710 N. Estes

Summary of Design Review Process and Outcomes

Prepared by: Brian Peterson, AIA, Urban Designer, TOCH

Notes prepared 8-17-22

Sketch 1

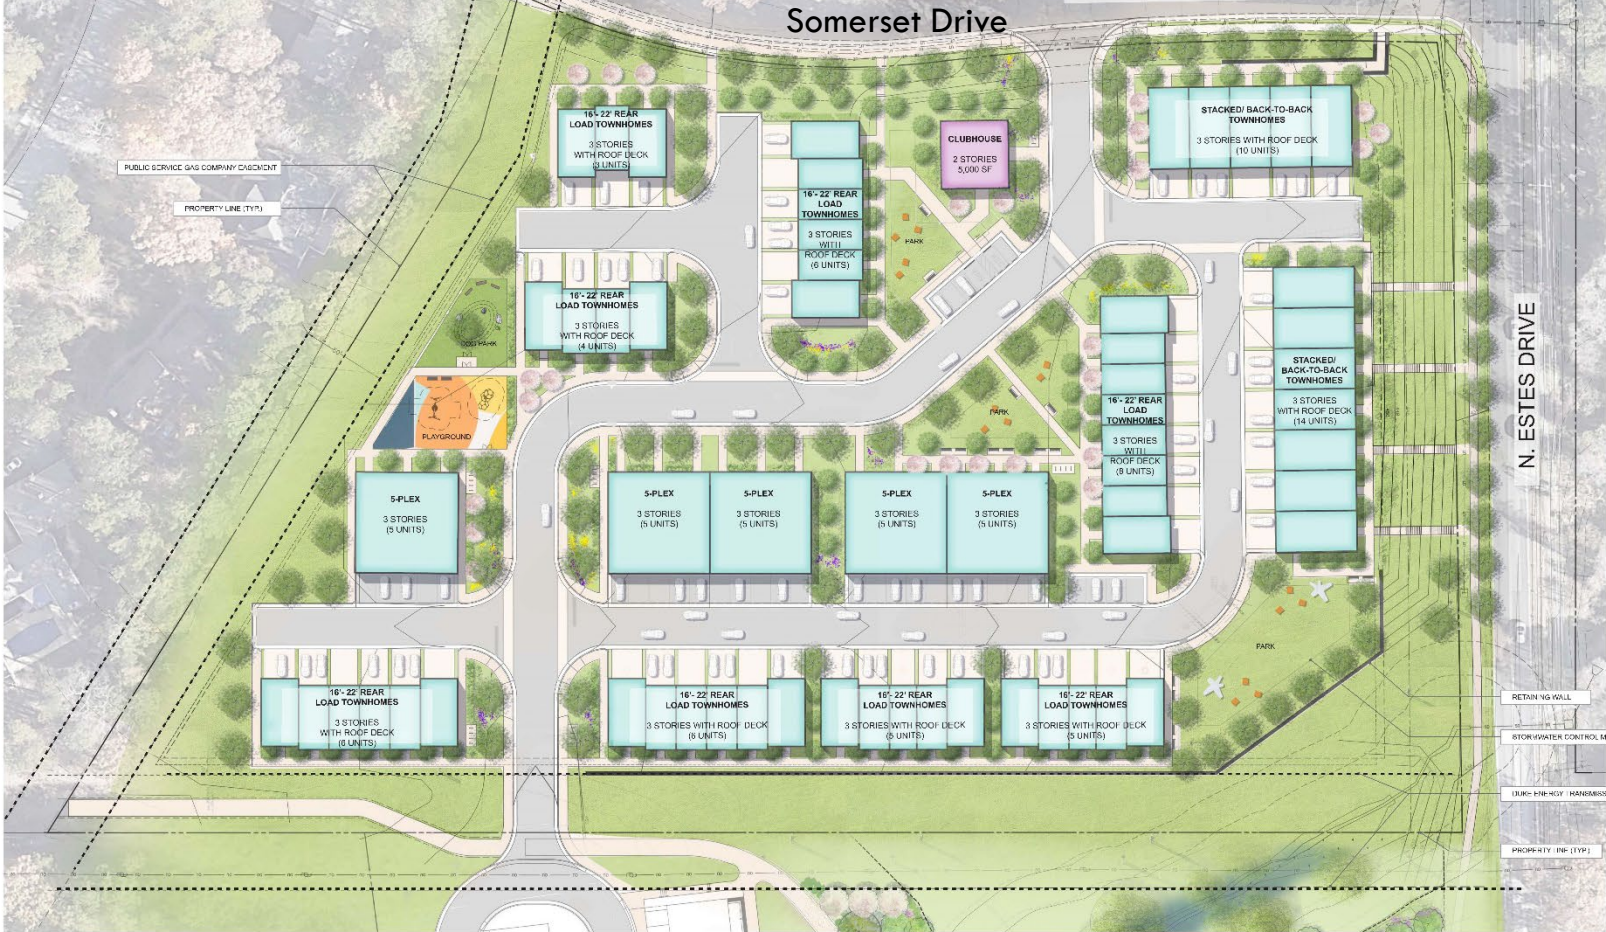
A design review meeting was held with the applicant earlier in the year, to discuss the site plan dated 12-28-21 (see attached sketch 1). For that meeting I prepared a concept sketch with suggested revisions (see attached sketch 2). The suggested changes in that sketch can be summarized as follows:
